Re: New Industrial Live/Work (**MLDFY2023-0002**)
Plan Review and City Engineer Comments

Thank you for the review on the above referenced project. The following represents our response to the plan review comments:

**RECORD OF SURVEY-MINOR LAND DIVISION
FOR NO PARK UNITS, LLC**

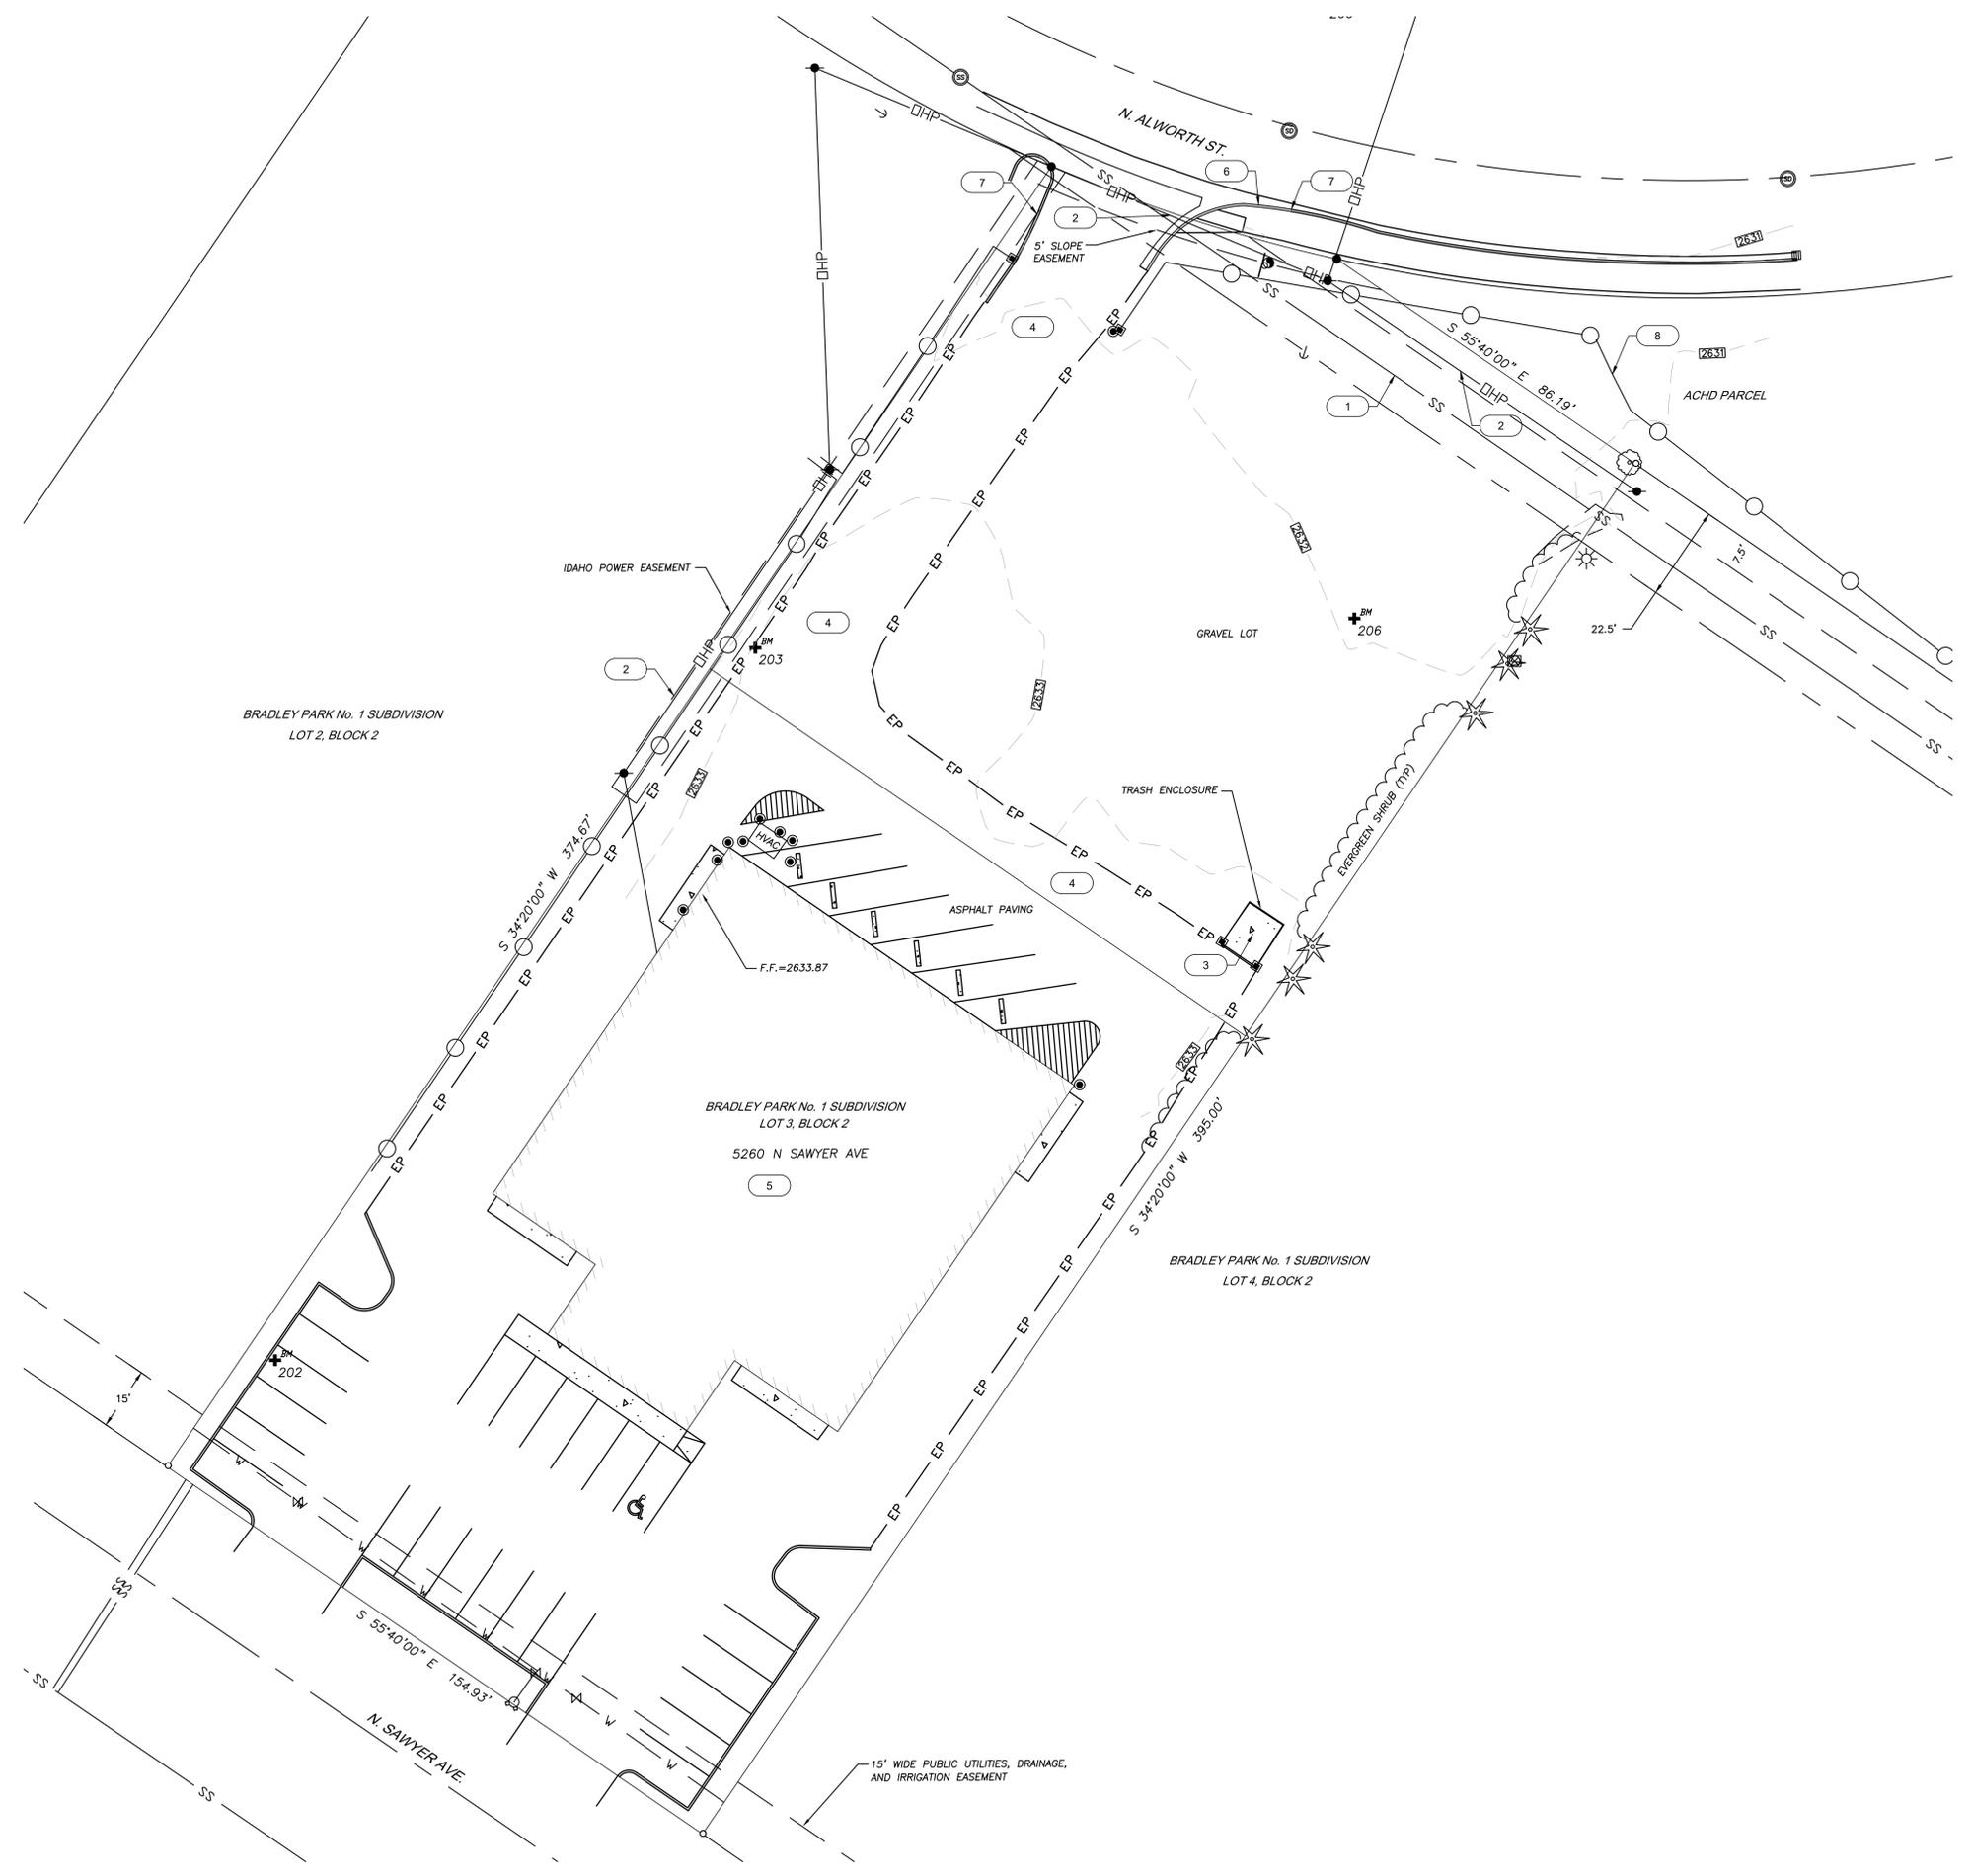
Item 3: *Provide cross access and cross parking agreements and easements.*
a. A cross access easement is not shown in the submitted ROS. Please note on the ROS that a cross access easement exists for parcels A and B with an associated instrument number. Noting and illustrating the easement on the ROS would be preferable.
b. A shared parking agreement between parcels A and B needs to be noted on the ROS per an instrument number. Address the City Engineer comments once received.

Item 5: *Please add the MLDFY2023-0002 file number to the Development Services signature paragraph on the ROS.*

Item 3: *Please modify the Certificate of Owner block to read as follows:
The undersigned, as owner(s) of the real property shown hereon, agree(s) to the new property lines within the original parcel shown hereon, and to create the new parcels shown hereon. Additionally, the owner(s) hereby declare and affirm that the boundary of the original parcel has been altered in accordance with Garden City Code to form new buildable parcels as shown hereon. The owner(s) further declare and affirm that the original parcel is no longer eligible for building permits from the city of Garden City. And the owner(s) agree(s) that they shall only seek building permits from the city of Garden City for projects located within the new buildable parcels using only the legal descriptions for the new buildable parcels.*

Item 4: *Please revise the wording of the city engineer's signature block to match the city requirements. See the city Lot Line Adjustment application.*

Item 6: *There is an Idaho Power easement shown along the west property line. Please fully define its location on the survey.*

Item 7: *Are all easements shown with their metes and bounds tags? We note the following easements in the title report:*

*#886339 – shown along north boundary – identify with Instrument Number
#9364503 – shown along west boundary - identify with Instrument Number
#103022040 – not shown?.*

Response: A cross access easement is shown on the revised ROS. There is no shared parking agreement between Parcels A and B.

Response: Please see revised ROS, Garden City file designation has been included.

Response: See revised ROS for corrected verbiage.

Response: See revised ROS for corrected verbiage.

Response: See revised ROS, dimensions associated with Idaho Power Easement have been provided. Sheets A1.0 and A1.1 have also been revised to show easement information.

Response: See revised ROS, easement associated with #103022040 has been identified.

C4.0

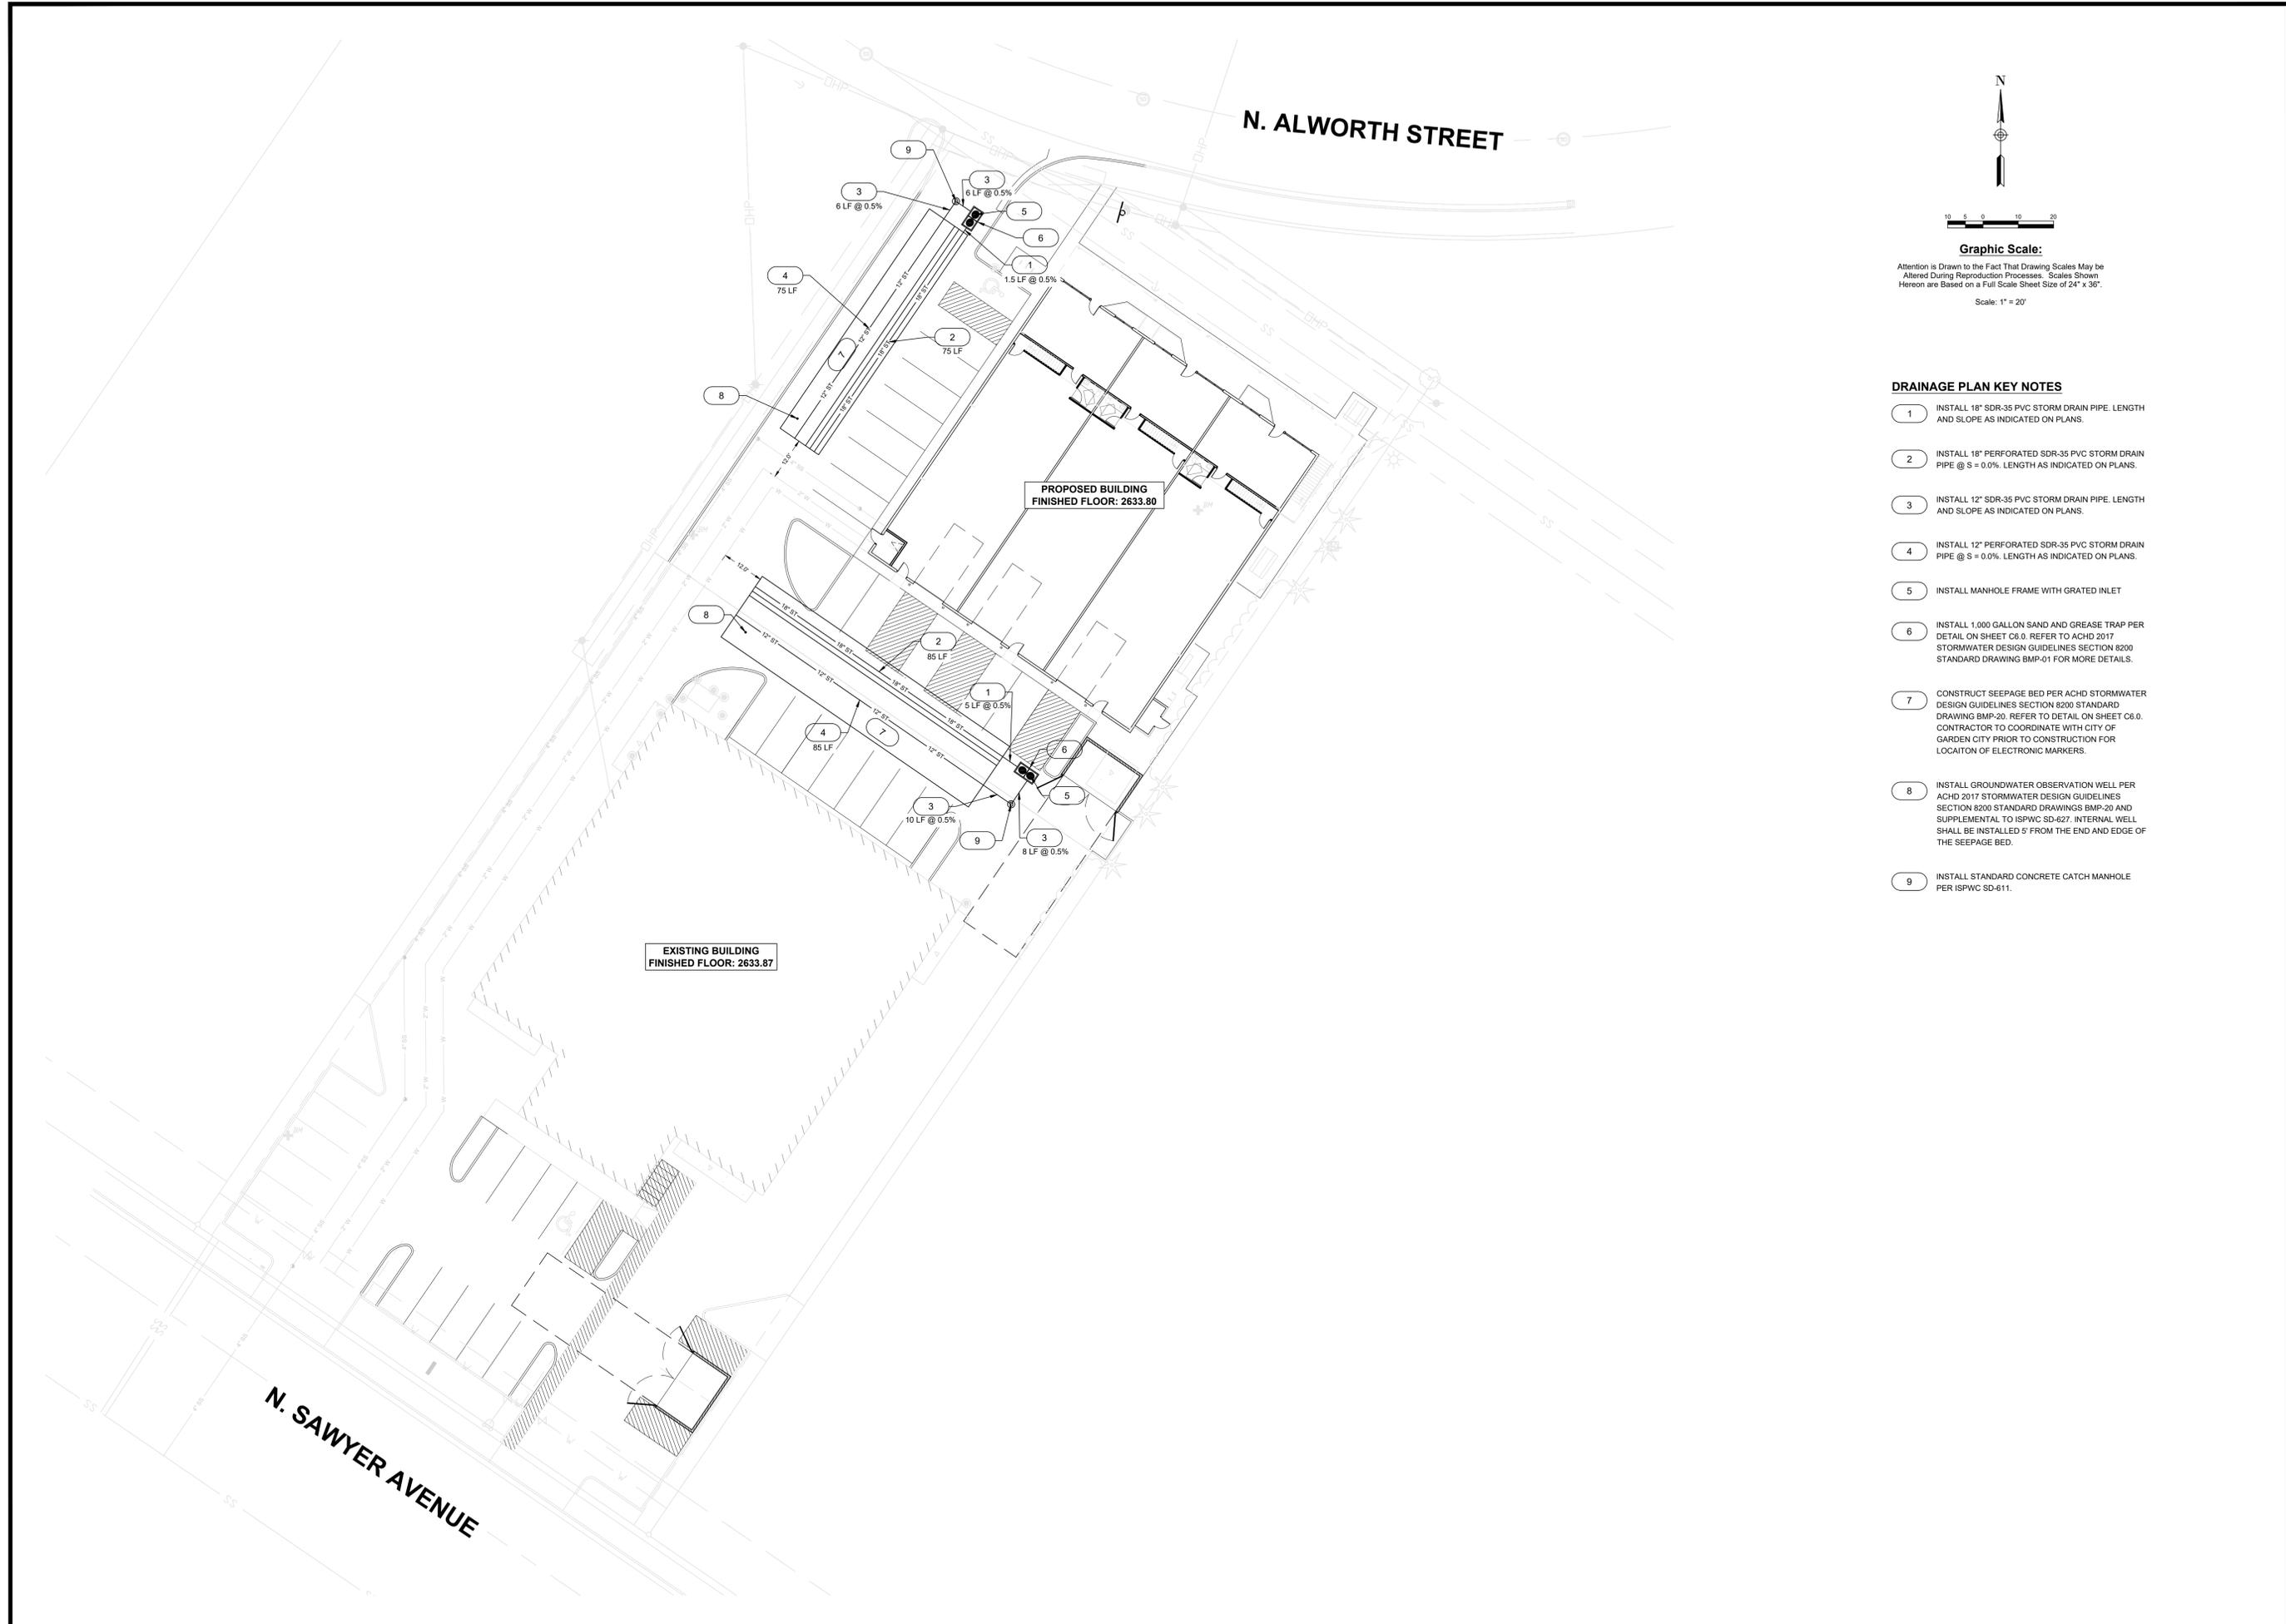
Item 8: *Garden City doubts that Boise City will allow the connection of the parcel adjoining Alworth to be connected to the Boise sanitary sewer line. Said line is an interceptor. Any direct connection would be a connection intrusion to the interceptor and would be unmonitored. Garden City would prefer/require to have all new connections to the Garden City collection system. This may require an upgrade to the existing sewer connection that runs across Sawyer. The sewer connection will need to be discussed with Garden City Public Works staff.*

Response: This has been confirmed that connection for the sanitary sewer line will be through Garden City's collection system. See revised sheet C4.0.
